CORRECTION TO TEST REPORT:

DTL1_FCC.DOC

6.6.2 Limits and results

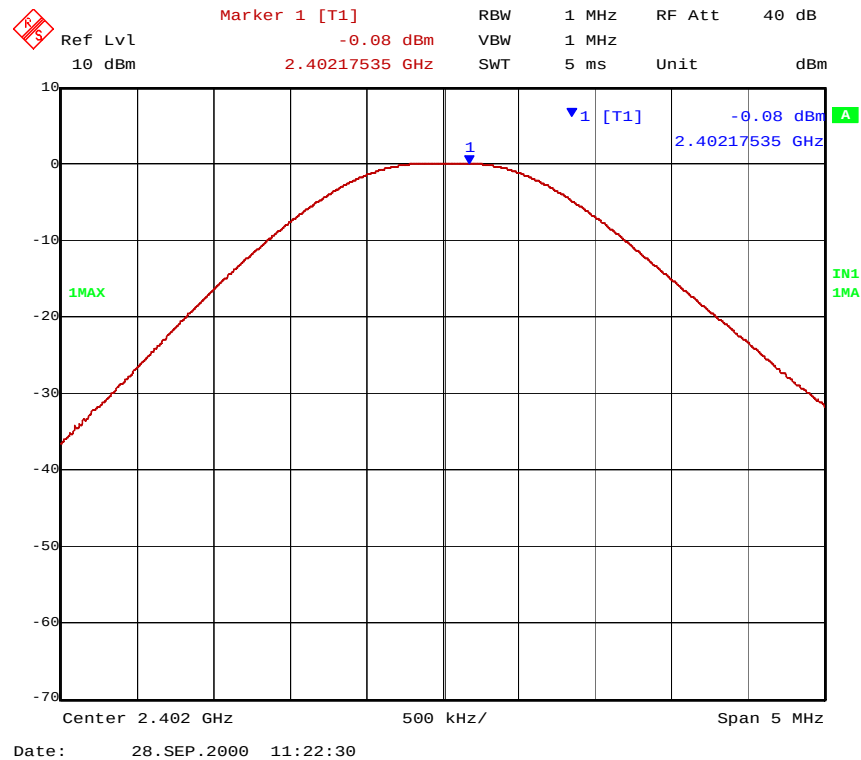
ERROR

The values in first table in test report section 6.6.2 are not correct.

CORRECTION

The correct values are copied from the calculation table to the value table.

The corrected page replaces the old one.
